**STATE OF HAWAII  
DEPARTMENT OF TRANSPORTATION  
HIGHWAYS**

**ADDENDUM NO. 1  
FOR  
INTERSTATE ROUTE H-1, MCCULLY STREET SEPARATION,  
SEISMIC RETROFIT  
FEDERAL-AID PROJECT NO. NH-H1-1(284)  
DISTRICT OF HONOLULU  
ISLAND OF OAHU**

**May 1, 2026**

**ISOMETRIC DETAILS**

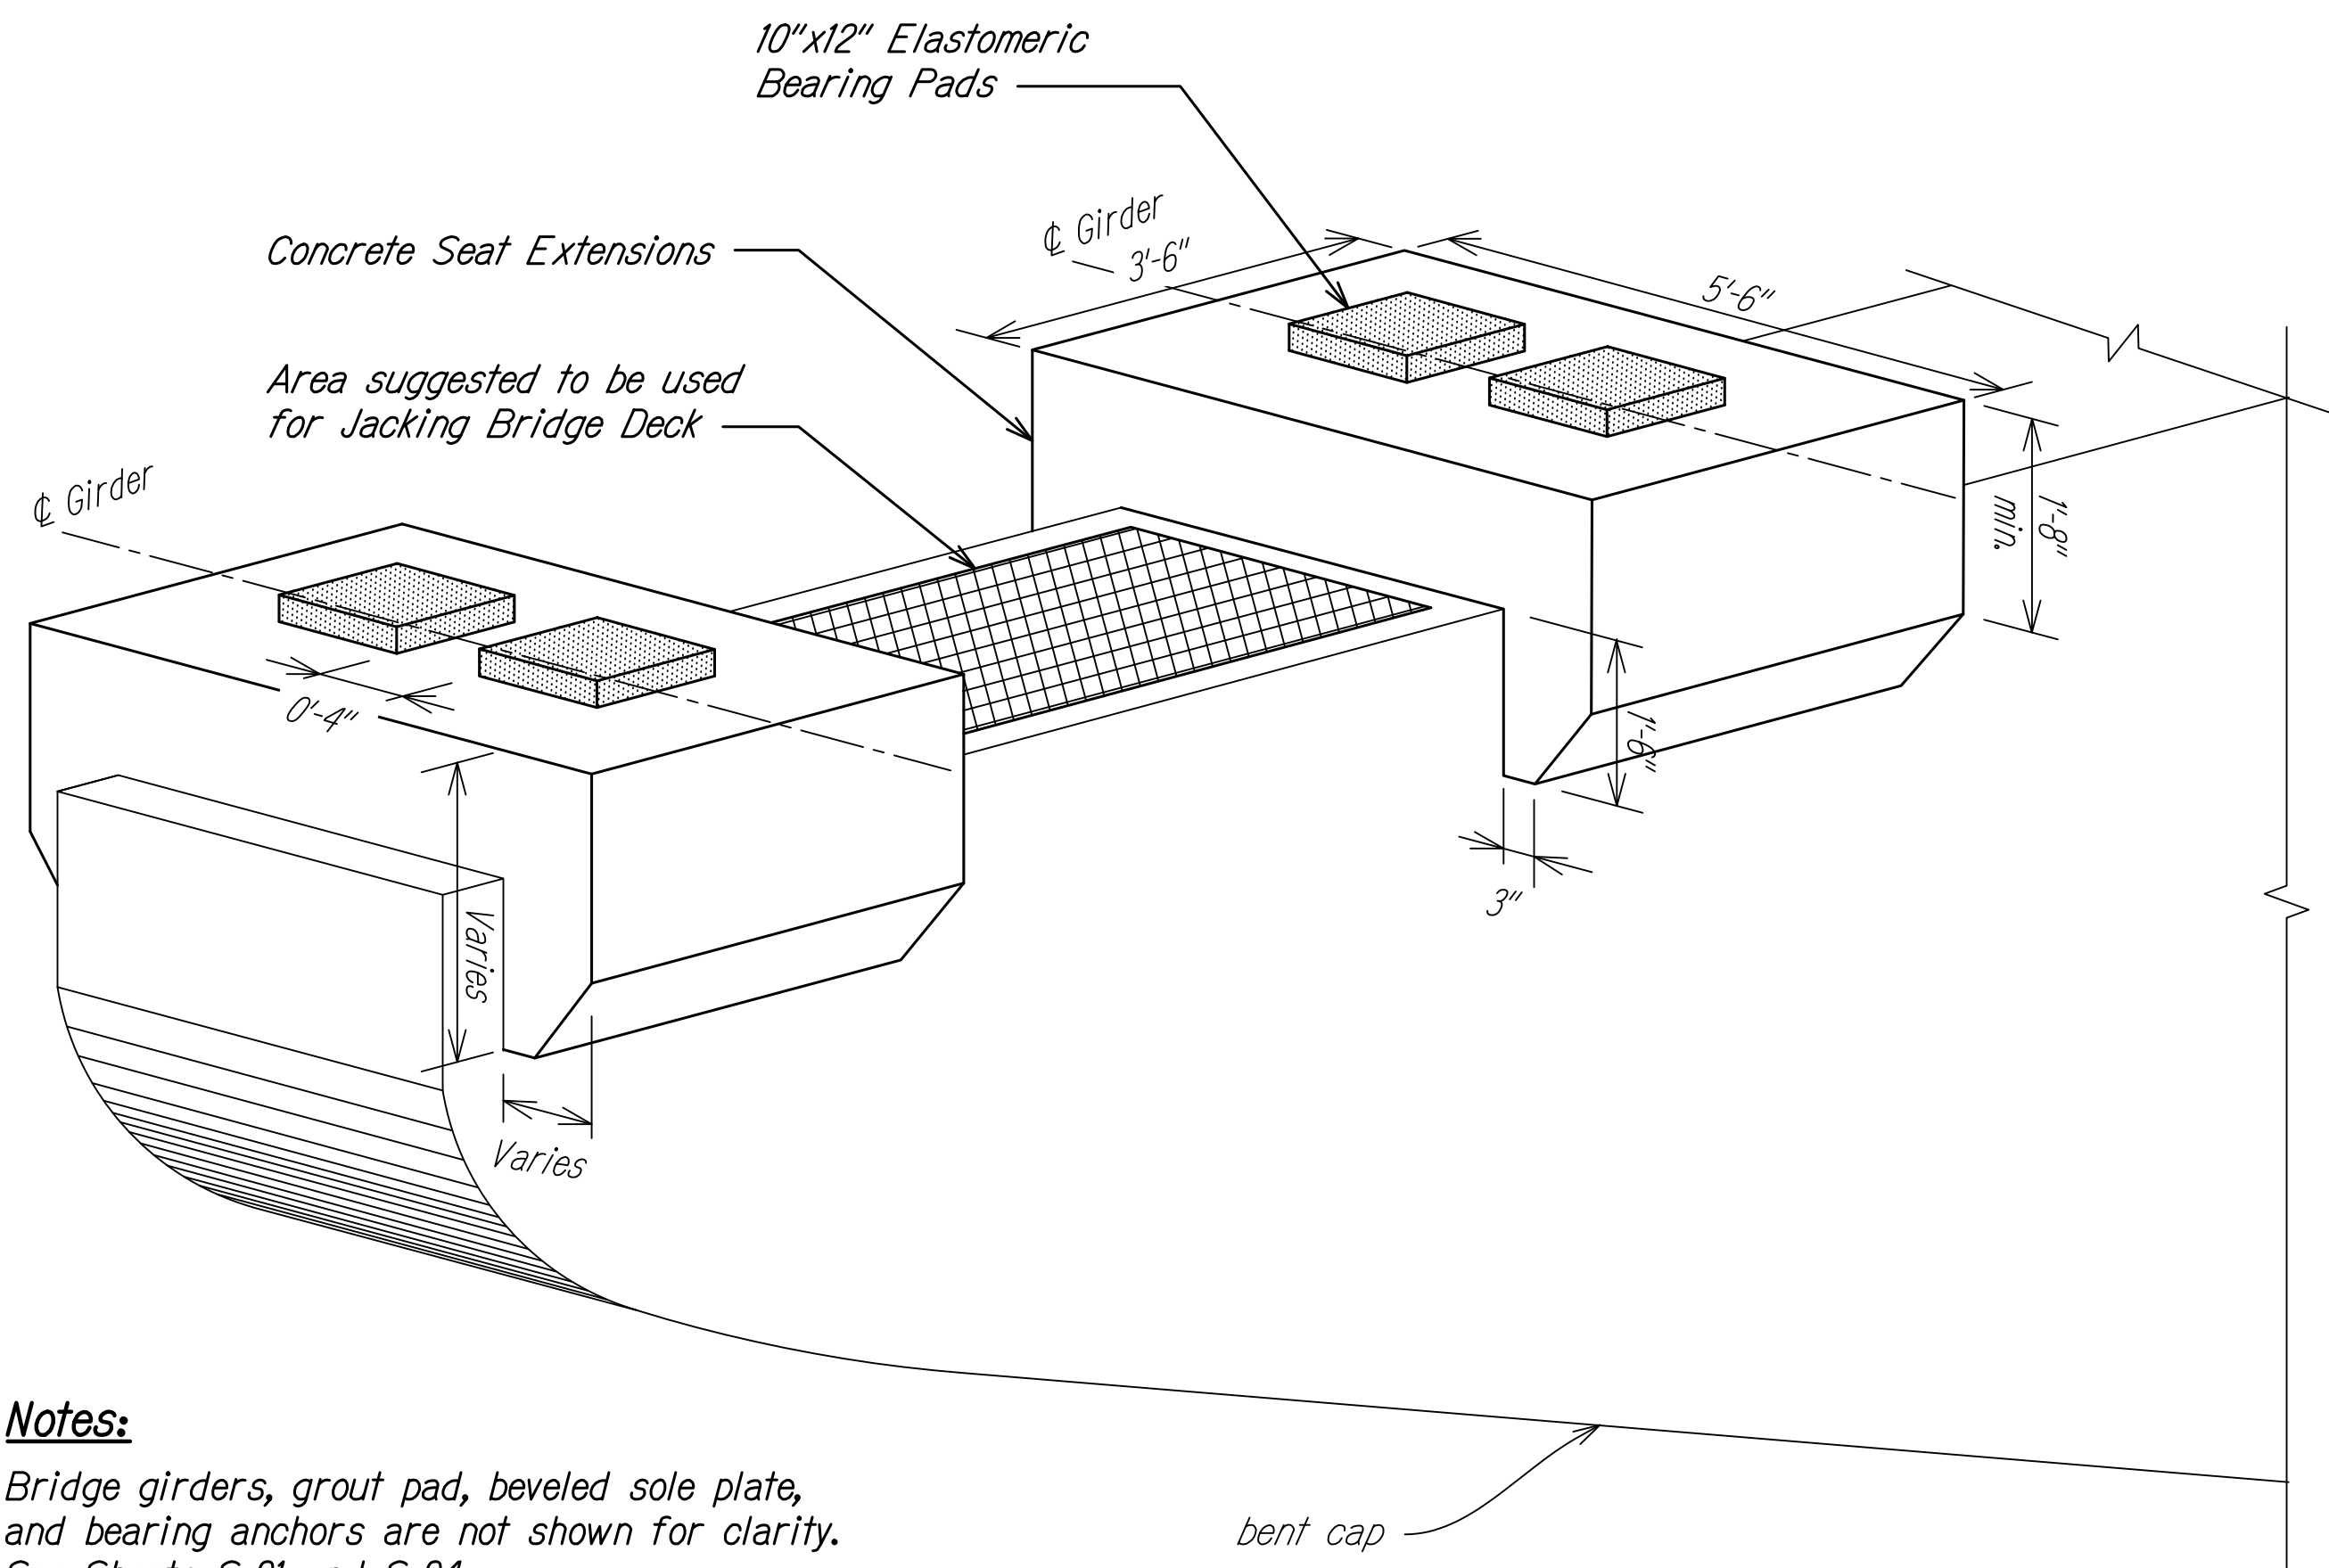
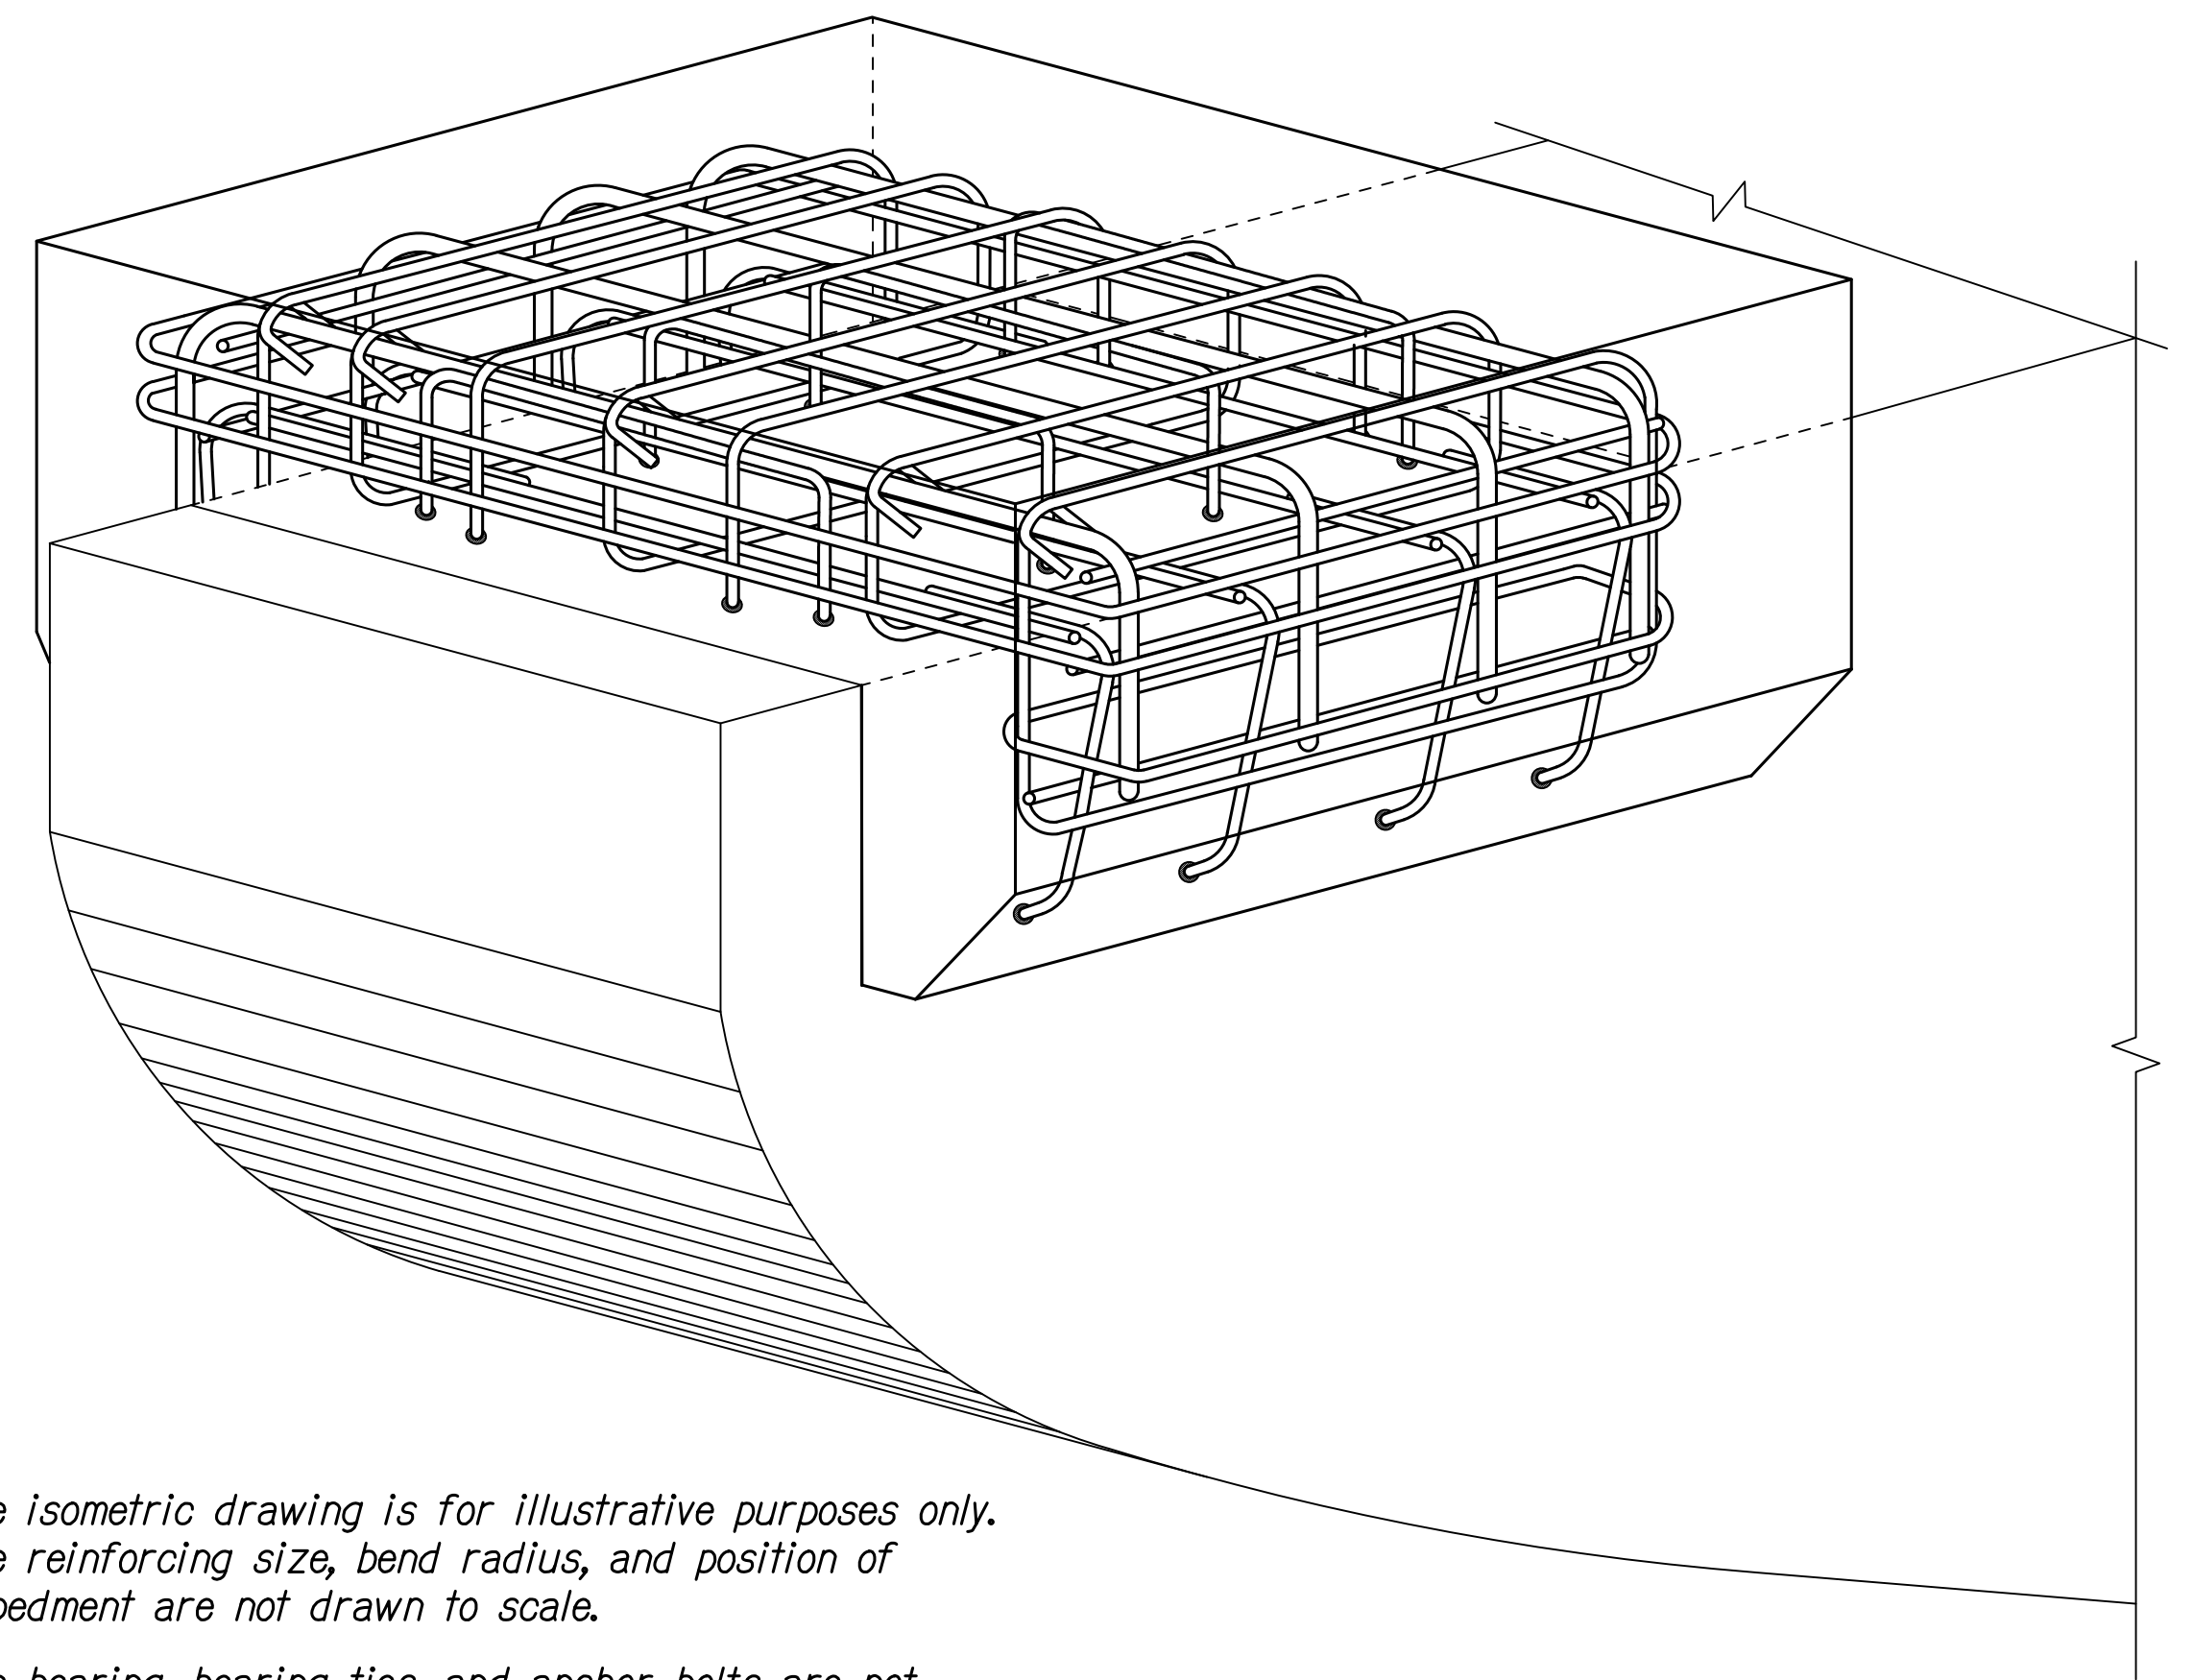
4/21/26	1	Added note for items not shown for clarity
DATE		REVISION

**Notes:**  
 1 Bridge girders, grout pad, beveled sole plate, and bearing anchors are not shown for clarity. See Sheets S-21 and S-24
